APPLICATION No. **16/01582/MJR** APPLICATION DATE: 29/06/2016

APPLICANT: Cardiff Gate International Business Park  
LOCATION: LAND AT MALTHOUSE AVENUE, PONTPRENAU  
PROPOSAL: PROPOSED DEVELOPMENT OF UP TO 150 HOMES,  
PROVISION OF NEW VEHICLE ACCESS,  
PEDESTRIAN/CYCLIST ROUTES, PUBLIC OPEN  
SPACE, LANDSCAPING DRAINAGE AND ASSOCIATED  
WORKS.

**RECOMMENDATION 1:** That planning permission be **REFUSED** for the following reasons :

Drawing Title  
Illustrative Masterplan

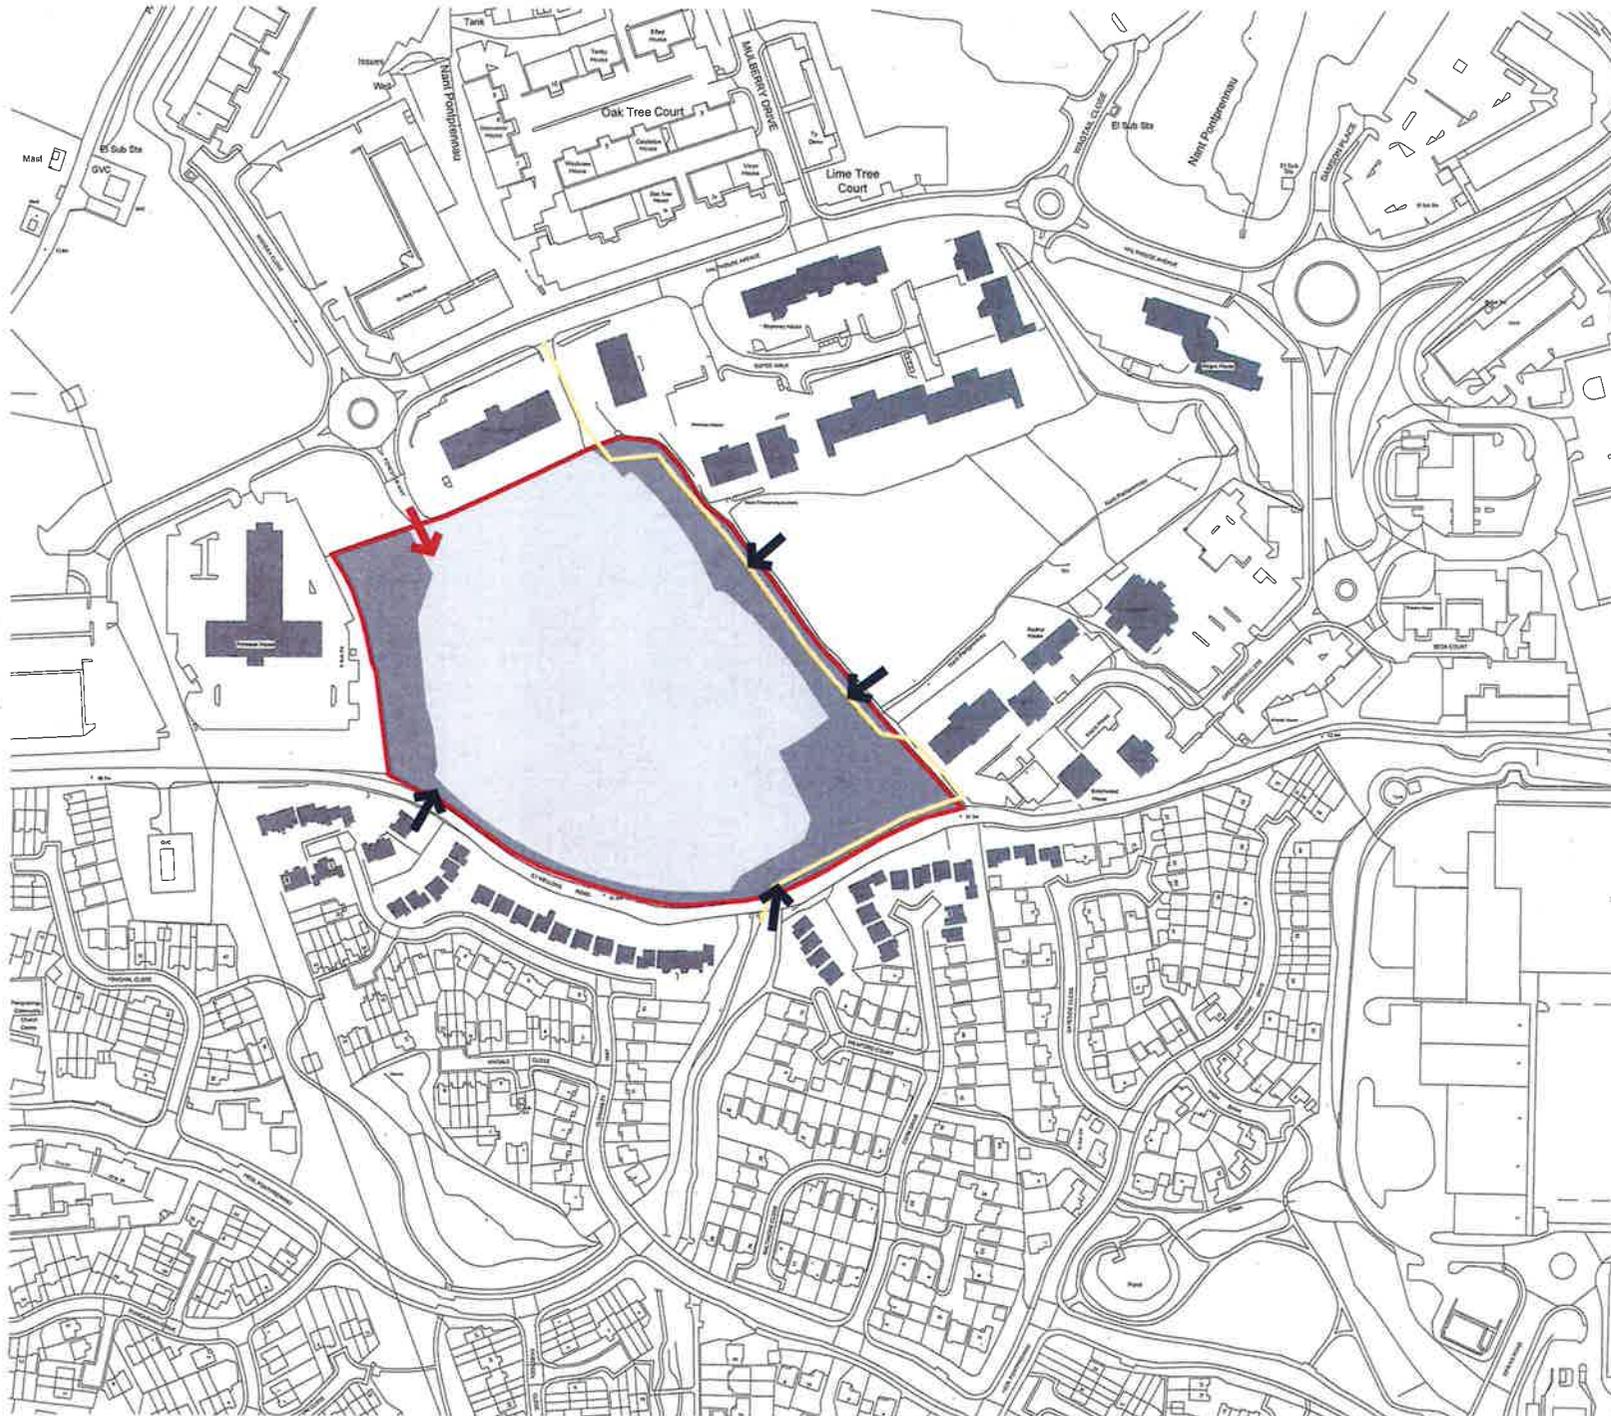
*Having compared the rev D and Rev E plans, the inclusion of a LEAP play area in the centre of the site rather than being hidden away in a more secluded and wet area of the site (and potentially over a sewer easement), is a welcome change to the design, providing access for children to local playing space. It is overlooked by houses giving good surveillance and forms a focal point of the scheme, which will help orientate visitors entering the site. Prior to any design for a play area taking place I would strongly recommend the applicant to hold a discussion with Parks Services to obtain technical and design guidance.*

*The Illustrated LEAP measures approx. 250m<sup>2</sup> rather than the usual 400m<sup>2</sup> we ask for, and the buffer zone is 16m to houses, whereas minimum 20m to boundary of property (rather than the property itself) is usually required to avoid disturbing residents.*

*Whilst the revised approach to central open space is supported, it will need to be larger to accommodate play area of required size (although happy to discuss design options on this – could potentially have equipment in central area plus natural play in the other space) and particularly to achieve buffer zones.*

*The latest version of the plan also appears to omit the attenuation pond from the open space to the south east, creating a much more usable open space, providing room for informal kickabout and other recreational uses. I'd be grateful if you could confirm that I have interpreted this correctly.*

*The revised layout with the central open space and set-back of some of the properties from the road does provide better options for tree planting, including larger species, which will be key in providing a focal point for the scheme.*

*My comments relating to contours and services remain as before. It's difficult to assess whether the proposals including the relocated play area are workable in practice without knowing the gradients involved.*

*The approach with regard to tree planting within easements is to remove it all, without clear evidence that this is necessary or required by the service providers. The information I have suggests that the service providers are likely to accept some trees within easements, and I attach the guidance they provide concerning gas pipes and sewers for information and consideration by the applicant, pursuant to amending their illustrative layout accordingly.*
